# THE GLEN AT WIDEFIELD FILING NO. 9

## RESIDENTIAL SUBDIVISION CONSTRUCTION DRAWINGS

**GLEN AT WIDEFIELD FILING NO. 9**  
**SPRING GLEN DRIVE (Sta. 30+00 to Sta. 43+00)**  
PLAN AND PROFILE  
EL PASO COUNTY, COLORADO

CENTERLINE PROFILE

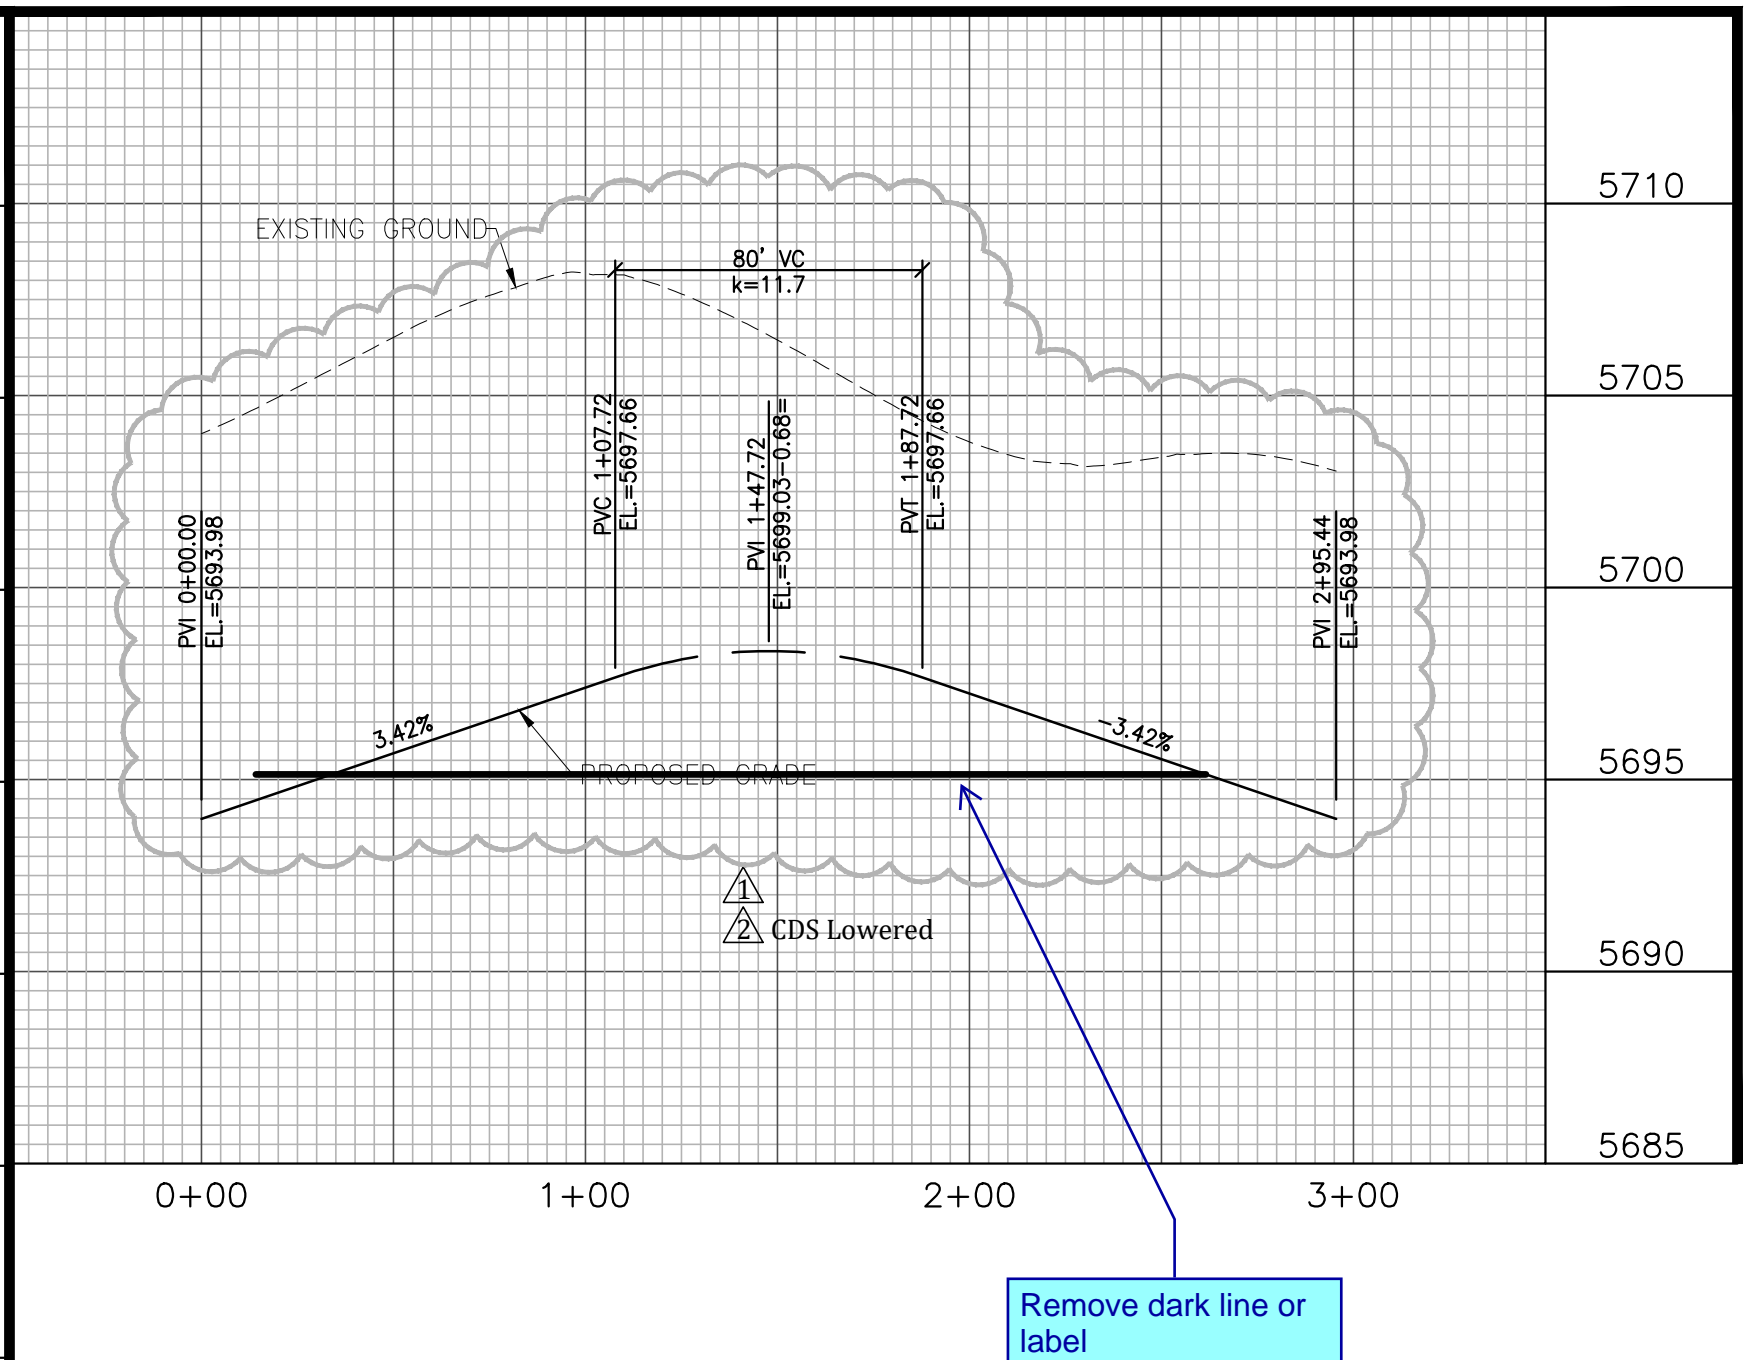
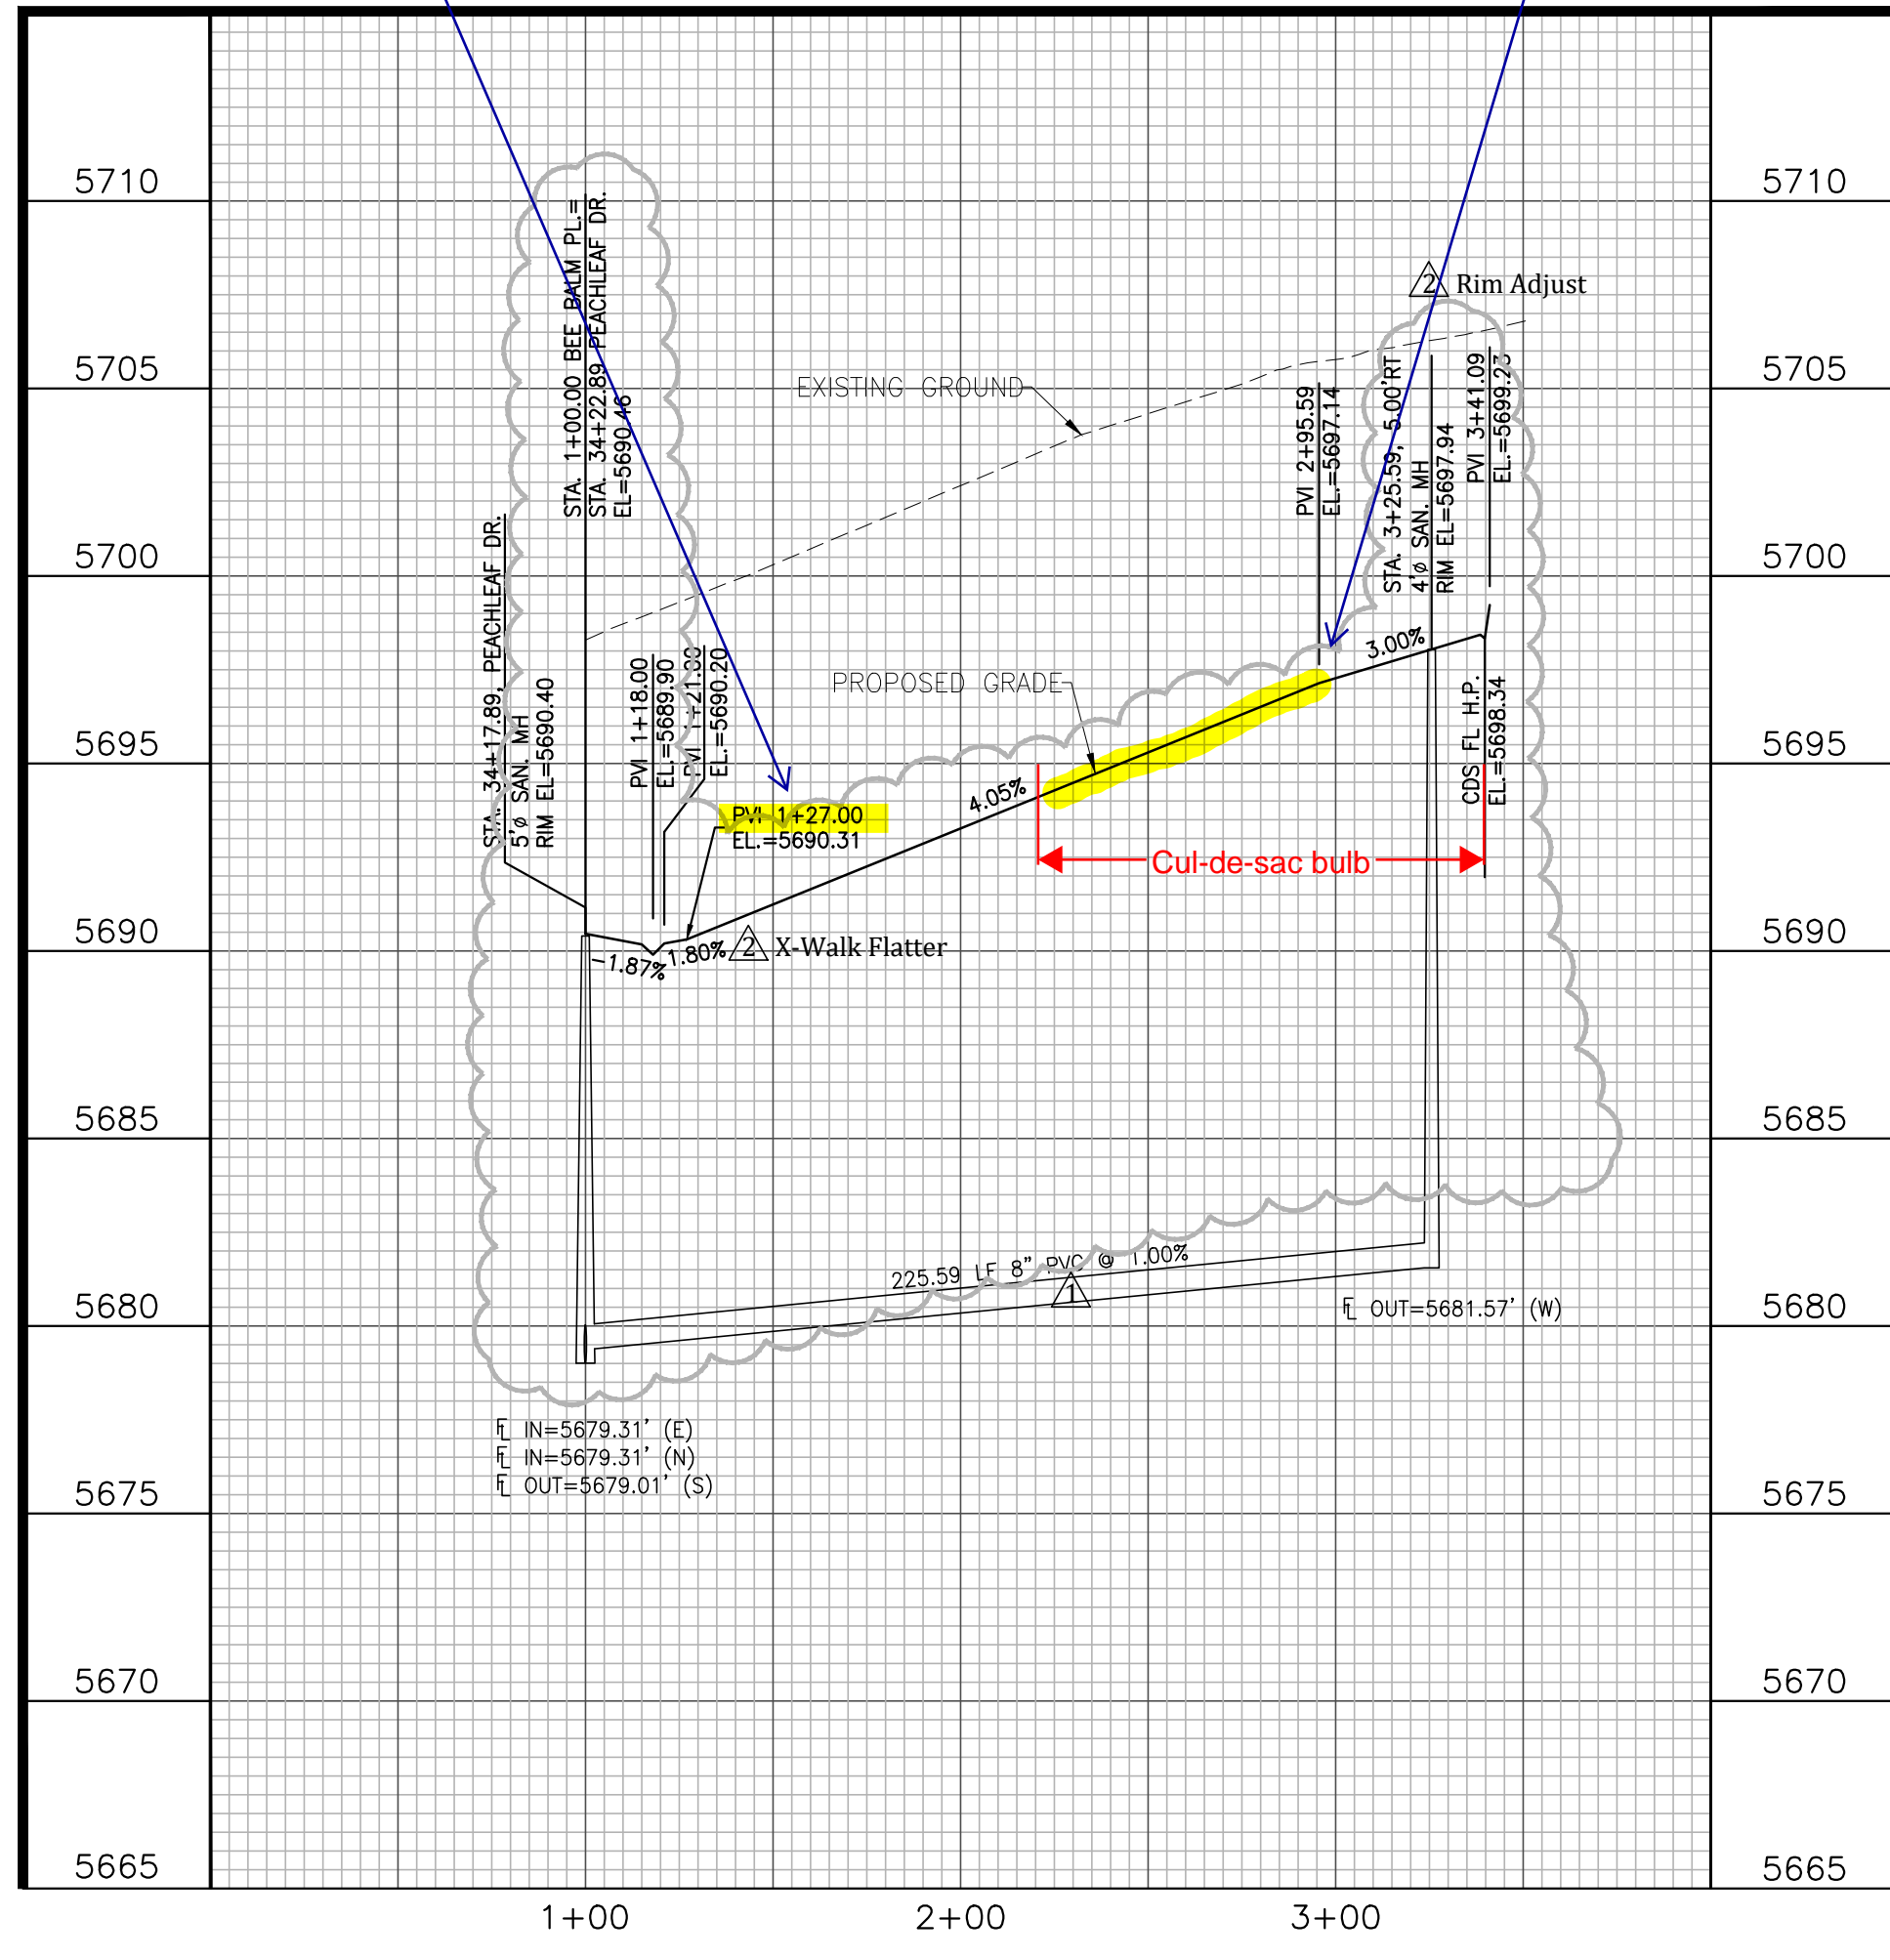
Revise profile. Cross slope of the pedestrian access path must meet ADA criteria of 2% max.

Unresolved. PVI and elevation does not match. The FL elevation is higher than the centerline elevation.

Revise centerline profile grade within the cul-de-sac bulb to 3.0% max. See ECM Section 2.3.8 Figure 2-31.

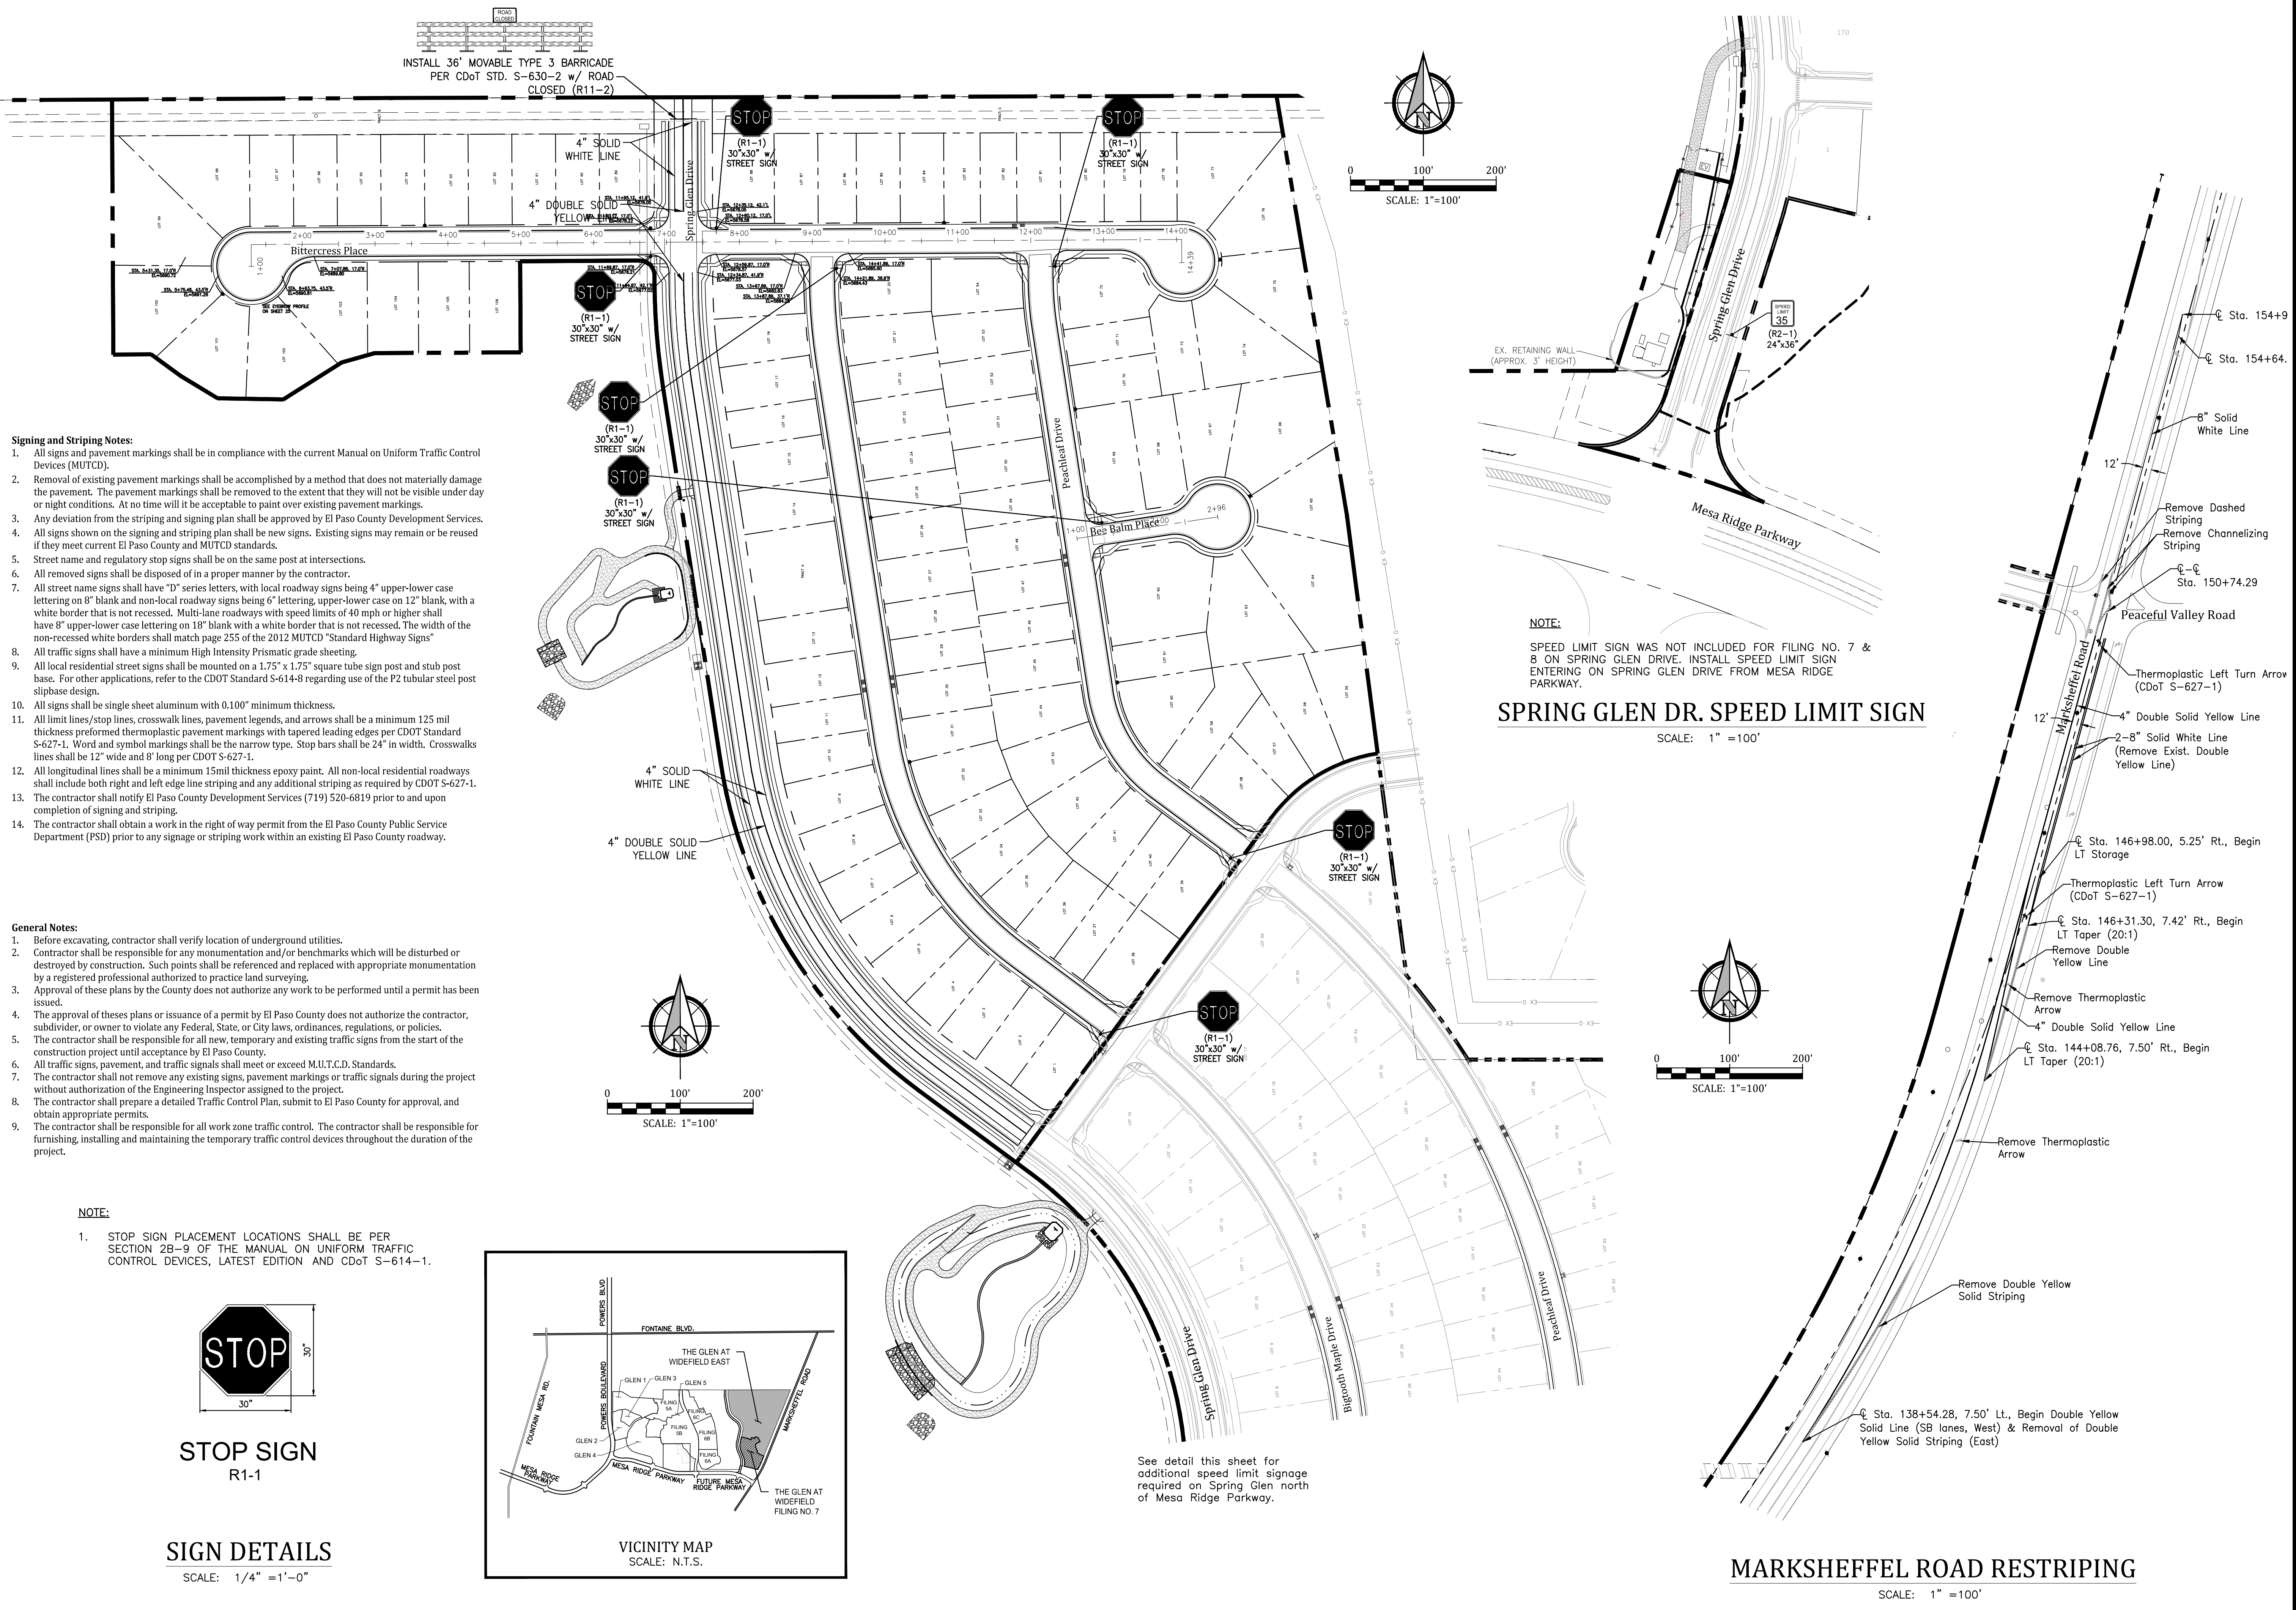
See detail this sheet for additional speed limit signage required on Spring Glen north of Mesa Ridge Parkway.
